# MIAMI BEACH

### Design Review Board

SUBJECT: DRB21-0686  
**2464 Prairie Avenue**

An application has been filed requesting Design Review Approval for the construction of a new two-story residence, including one or more waivers and variances from the maximum lot coverage, maximum unit size and maximum yard elevation, to replace an existing architecturally significant pre-1942 home.

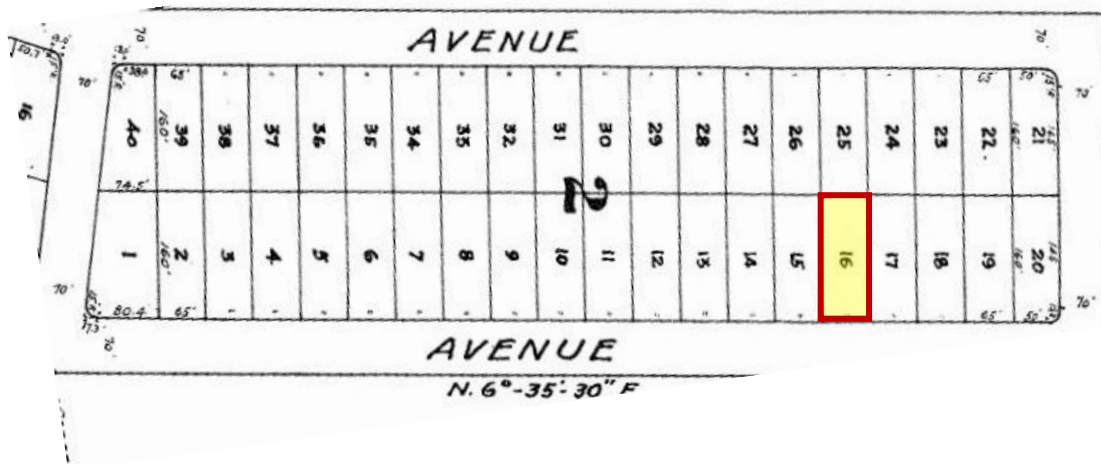
However, based on the size and location of the property and the fact that this is new construction, staff finds that there are no special conditions on this property for the variances requested and the approval of these variances would confer a benefit to the applicant denied to other surrounding properties. The variances requested are not the minimum variances required to make a reasonable use of the property.

Staff would note that as part of the latest amendments to the single-family regulations last year, the lot coverage and unit size section was modified to remove courtyards enclosed on three (3) sides among other requirements. Terraces and covered areas also changed in the way they are counted and now all covered areas, eyebrows and roof overhangs exceeding 5'-0" from the building walls or columns shall count as part of the lot coverage. In this regard, staff believes that with minor modifications to the design, the lot coverage could be reduced to comply with the Code requirements. Specifically, at the rear terrace, the portion exceeding 5'-0" could be replaced with an open trellis, which removes this area from the total lot coverage. The excess in lot coverage proposed is 130 sf and this area exceeding 5'-0" is approximately 168 sf. With this change the lot coverage would be below the maximum 30% allowed.
